[Docket No. 98-CE-83-AD; Amendment 39-10971; AD 99-01-04]

Airworthiness Directives; Avions Pierre Robin Model R2160 Airplanes

Airworthiness Directives; British Aerospace Jetstream Model 3101 Airplanes

Figure 1

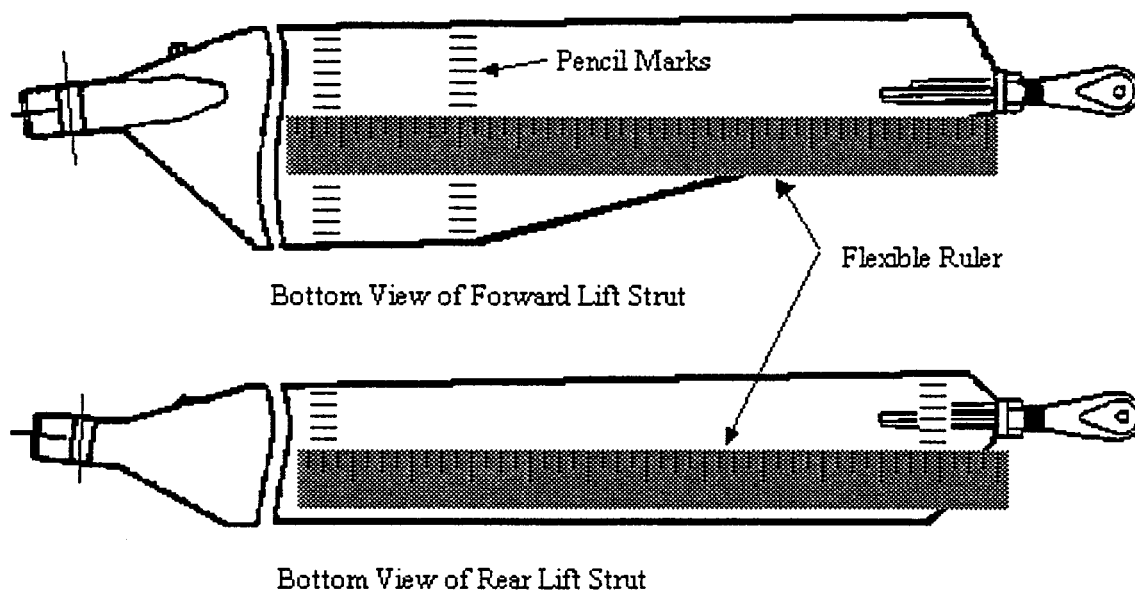
• **Note:** A reading shall not exceed .041-inch. If a reading exceeds .041-inch, repeat steps 13 and 14 of the Instrument Setup section before proceeding further.

• **Note:** The strut wall contains a fabrication bead at approximately 40% of the strut chord. The bead may interfere with accurate measurements in that specific location.

8. A measurement of 0.024-inch or less shall require replacement of the strut prior to further flight.

shall be considered suspect. These areas may have a remaining wall thickness of less than 0.020-inch, which is below the range of this setup, or they may have small areas of localized corrosion or pitting present. The latter case will result in a reduction in signal strength due to the sound being scattered from the rough surface and may result in a signal that includes echoes from the pits as well as the backwall. The suspect area(s) shall be tested with a Maule "Fabric Tester" as specified in Piper Service Bulletin No. 528D or 910A.
